Figure 1 of the application is shown below:

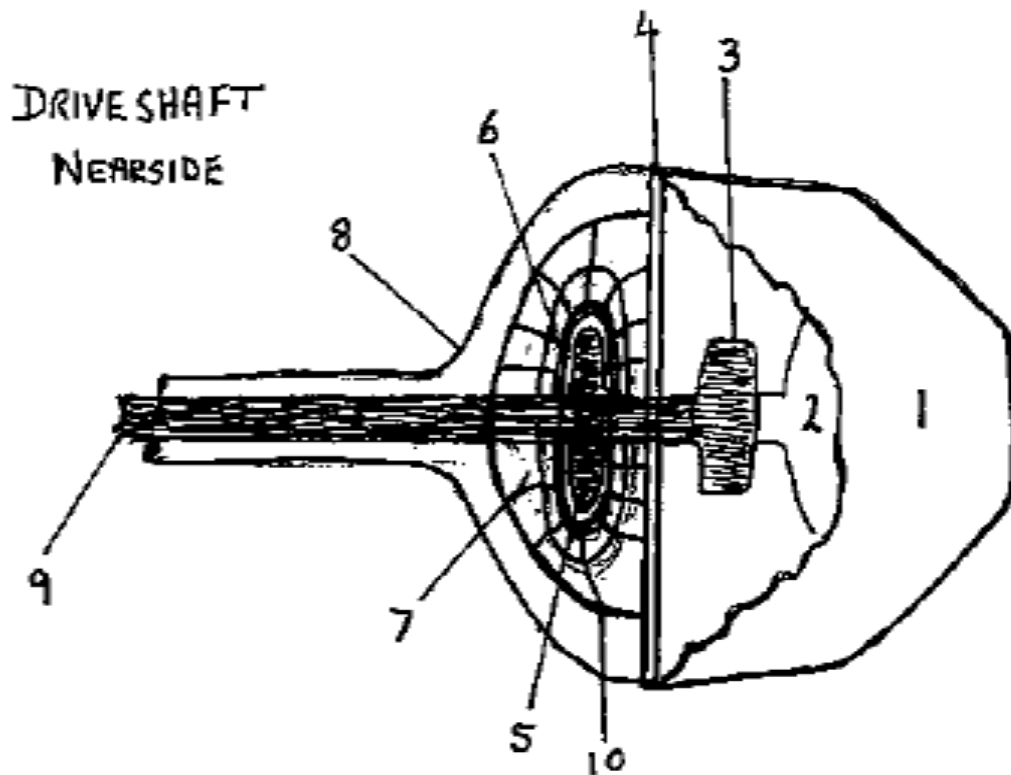
- 5 It is unclear from the description how the outer mechanism of the turbine (labelled 6 on the above figure), which is intended to remain static, is fixed, as no shell/casing of the driveshaft or axle is shown.

- 7 If I were to assume, for the sake of argument, that a shell/casing of the driveshaft or axle were implicit, it is not clear how the blades of the turbine would rotate without interfering with the shell/casing of the driveshaft or axle. Whilst several scenarios were discussed at the hearing, none could be achieved without a significant level of inventive skill.

- 8 It follows that the specification does not disclose the invention in a manner which is clear enough and complete enough for the invention to be performed by a person skilled in the art.

- 9 I therefore agree with the examiners assessment that the invention is not sufficiently disclosed to meet the requirements of section 14(3) of the Act. Since

it is not possible to add new information to the specification in order to overcome this defect, I therefore refuse this application under section 18(3) of the Act.
